Florida Department of Environmental Regulation

Attached is one copy of the Technical Evaluation and Preliminary Determination and proposed permits for Georgia-Pacific Corporation to implement modifications/enhancements on the No. 4 recovery Boiler (RB) and No. 4 Lime Kiln, which have the potential to increase their total process input and product rates and potential pollutant emissions. The No. 4 Smelt Dissolving Tanks (North and South units) will also have the potential to increase the total process input rate of smelt and the potential pollutant emissions due to the increase of black liquor solids burned in the No. 4 RB. The proposed modification will result in new source review for Prevention of Significant Deterioration for the pollutants PM (particulate matter), PM₁₀, NO_x (nitrogen oxides), CO (carbon monoxide), and VOC (volatile organic compounds) pursuant to F.A.C. Rule 17-2.500(5).

The Department has reviewed the above referenced application packages received February 13, 1991. Based on a technical evaluation, the applications are deemed incomplete. Please submit to the Department's Bureau of Air Regulation a response to the following, including all calculations, assumpt

Figure A-1 LOCATIONS OF REVISED PLANT PROPERTY RECEPTORS

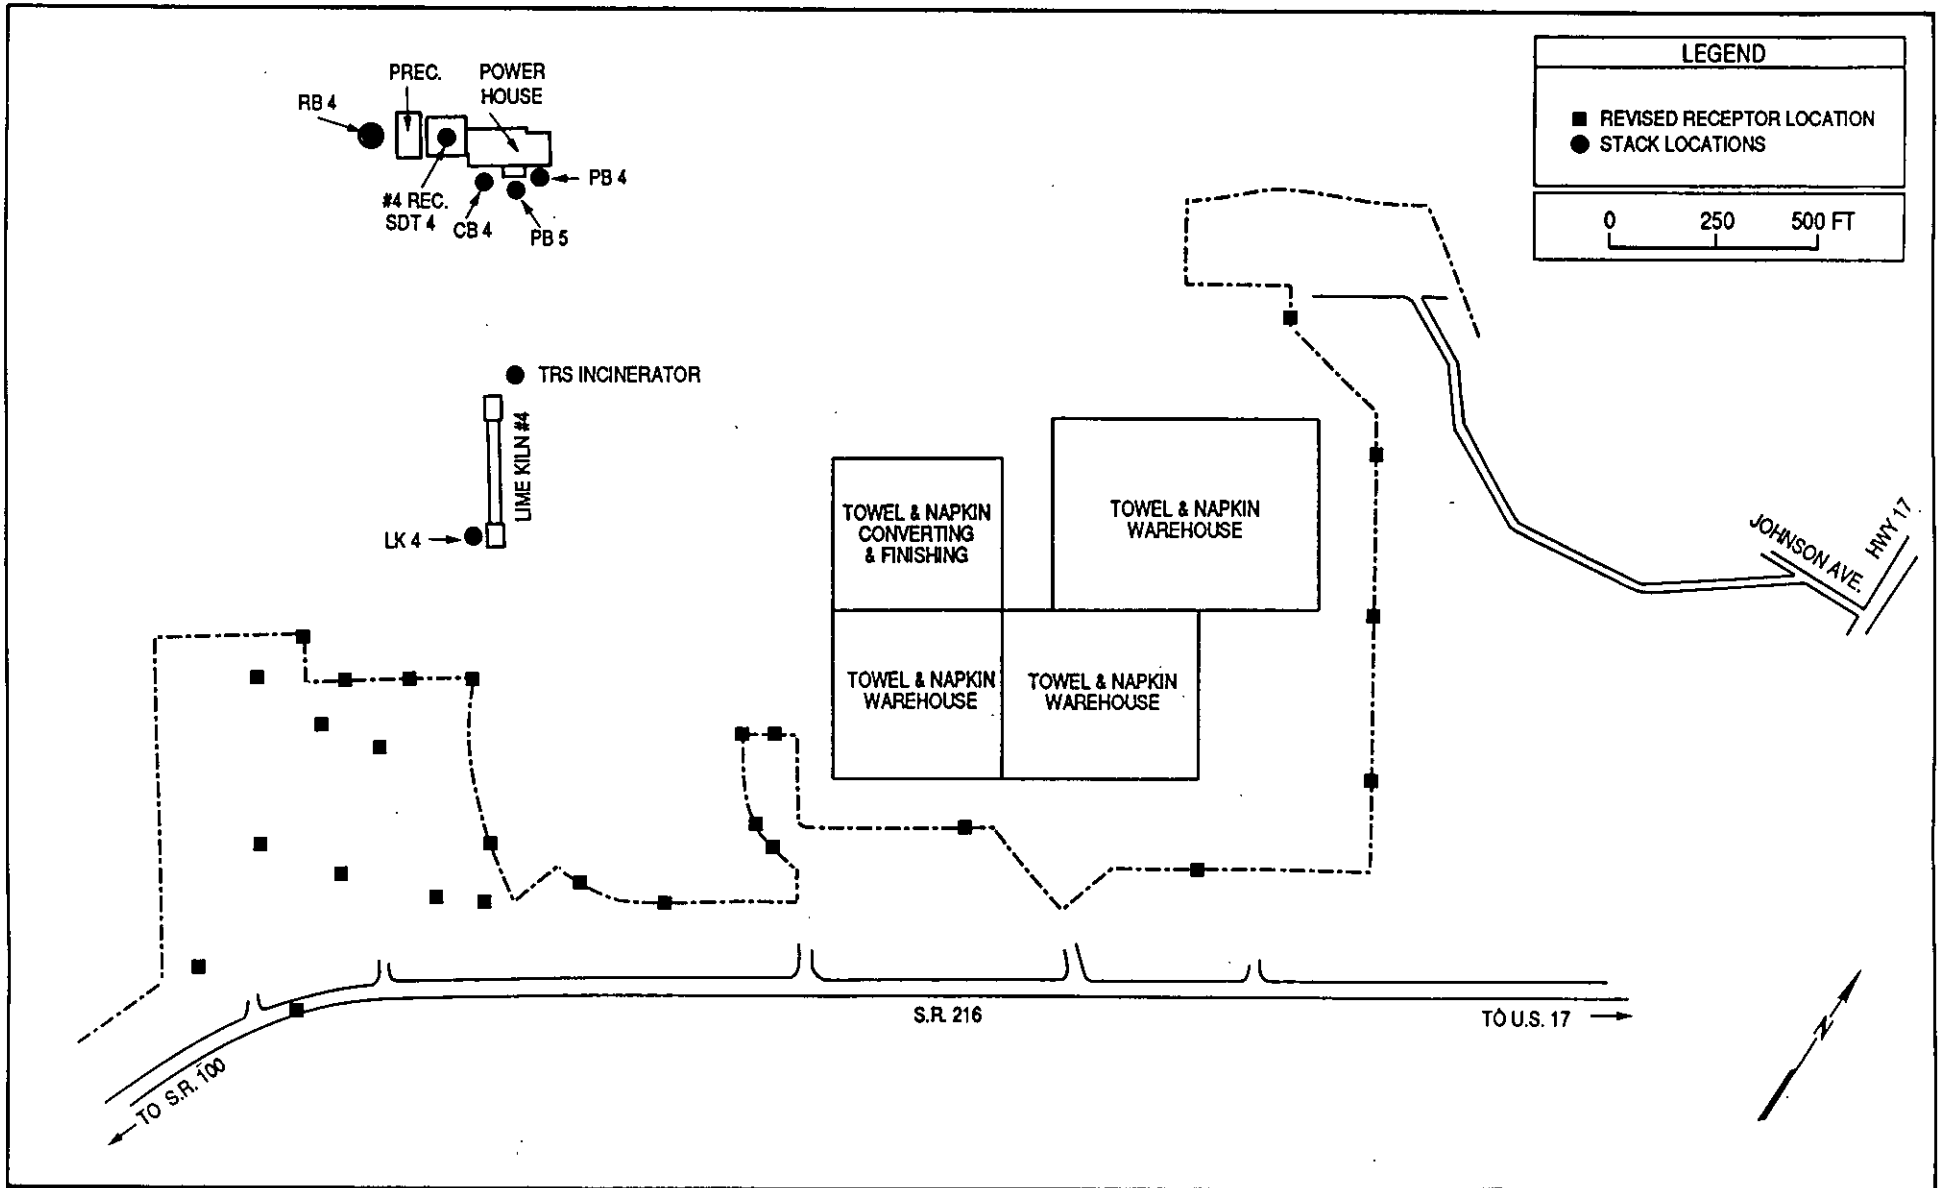
The property boundary question dealt with public accessibility. The area detailed on the map which was enclosed in the application is accurate. Public accessibility is controlled in several ways. The boundary closest to the mill is fenced and patrolled by security guards. The other boundaries are secured thru a combination of other means which include gates, posted signs, security patrols, and natural barriers such as thick vegetation. KBN checked the areas just outside the fences in the areas which had the greatest likelihood of having ambient problems and found none (modeling supporting this conclusion is attached).

In the dispersion modeling analysis presented in the permit application, receptors were placed at the extent of Georgia-Pacific property (i.e., at the edge of State Road 216 and U.S. Highway 17) at 10-degree increments from 40 to 200 degrees relative to the TRS incinerator stack. In response to FDER comments, additional dispersion modeling was performed locating plant property receptors at the Georgia-Pacific fence line bordering State Road 26 and U.S. Highway 17. The locations of the revised receptors are presented in Figure A-1. A comparison of the locations of the original and revised plant property receptors is presented in Table A-1. A summary of additional receptors used to provide 100-m resolution in the zone between original and revised plant property receptors is presented in Table A-2.
